CERTIFICATE OF APPROPRIATENESS

Houston Archaeological & Historical Commission April 21, 2022 HPO File No. HP2022 0083

ITEM D5 2010 State Street Old Sixth Ward

HPO File No. HP2022_0083

SOUTH FRONT ELEVATION PROPOSED

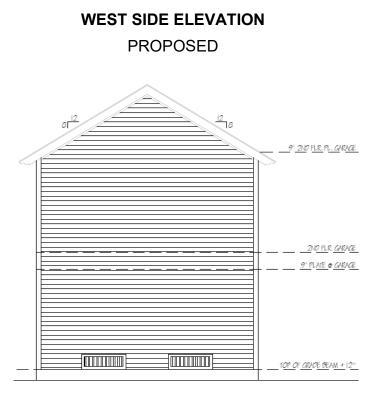
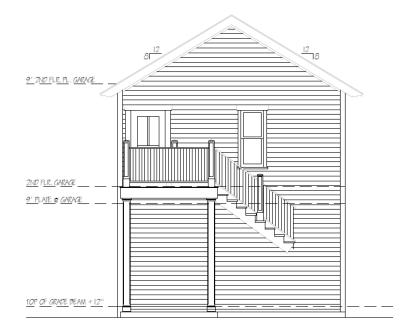
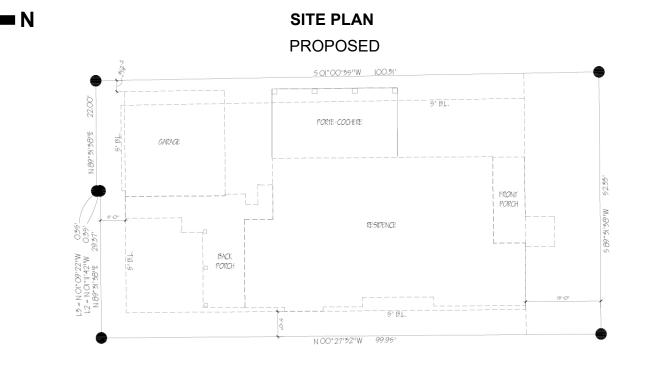
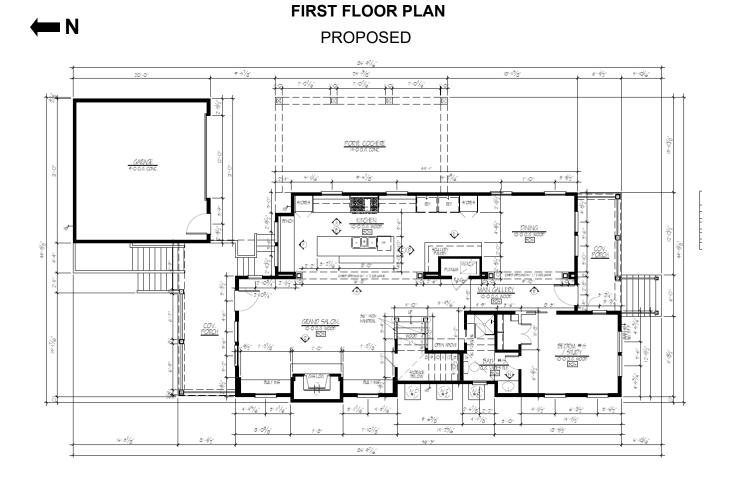
Recommendation: Approval with conditions that the roof of the garage will be 6:12 instead of 8:12.
